Review of 2024 Annual Update to Gas Supply Plan of EPCOR

Natural Gas Limited Partnership

EB-2024-0139

Responses to OEB Staff Questions

Table Staff 2-1 – Winter Peak

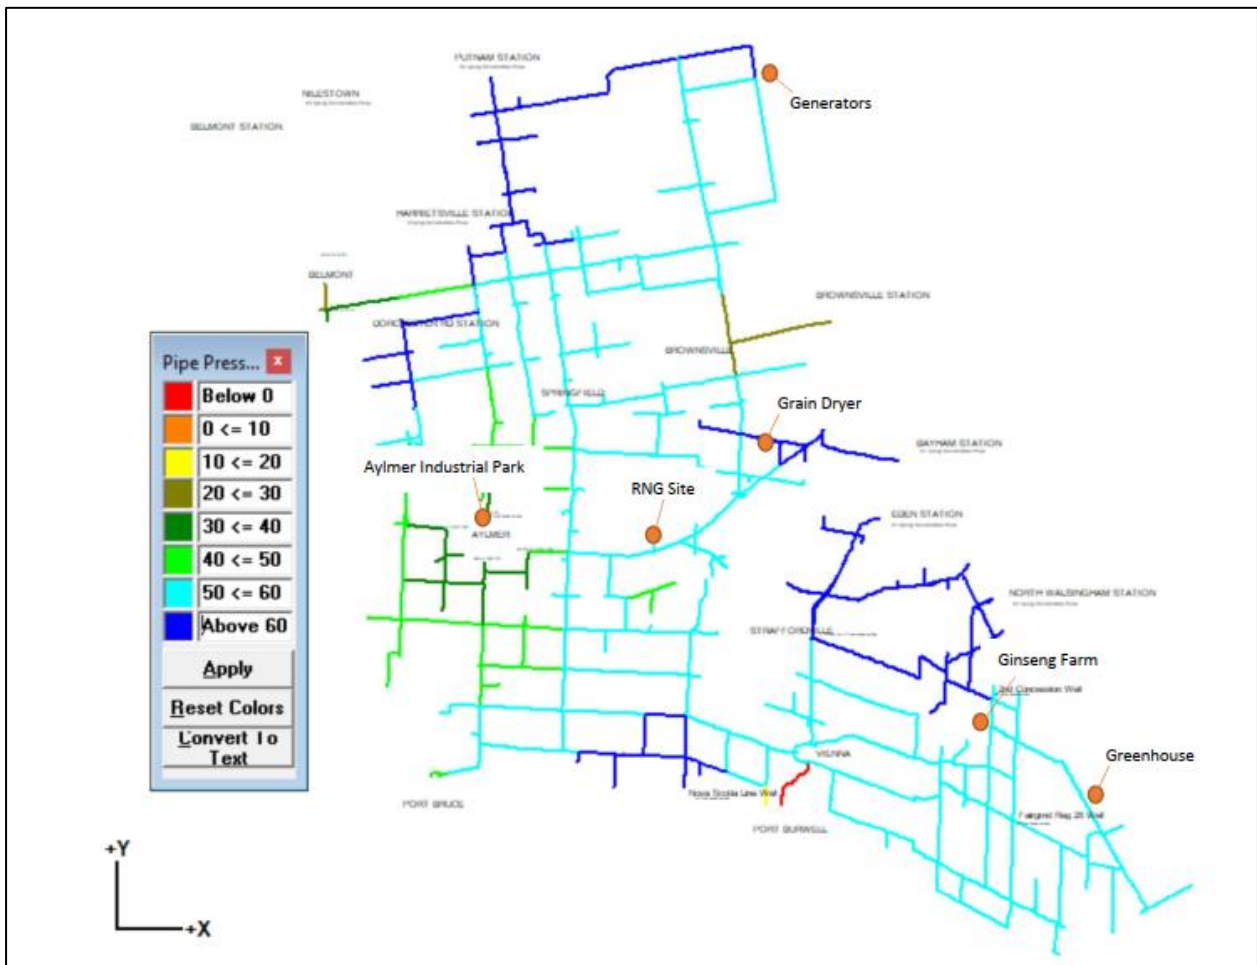
iii) Where is EPCOR anticipating these customers to be located geographically? Please overlay a map of where low-pressure spots are and where the anticipated customers will be.

EPCOR RESPONSE: EPCOR is anticipating these customers to be located in areas of the system where there are no identified low pressure issues. Please see below maps of the distribution system depicting the location of the customers and pipe pressures observed for both the Winter peak and Fall peak cases.

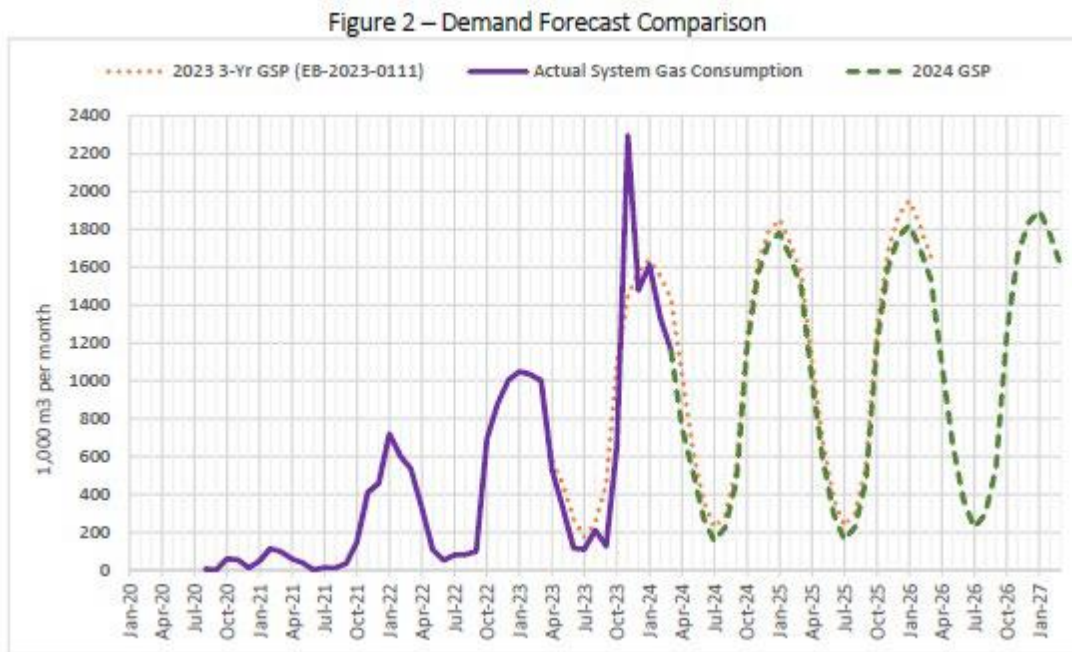
a) Please provide a discussion of what happened to the system in November 2023 that resulted in a spike in demand.

i. If the system is able to meet peak demand as shown in Figure 2 in November 2023, why would it not be able meet demands in the winter season?

EPCOR RESPONSE: In November 2023 grain dryer consumption was much higher than anticipated.

EPCOR RESPONSE: EPCOR is able to meet peak demand in the winter (February).
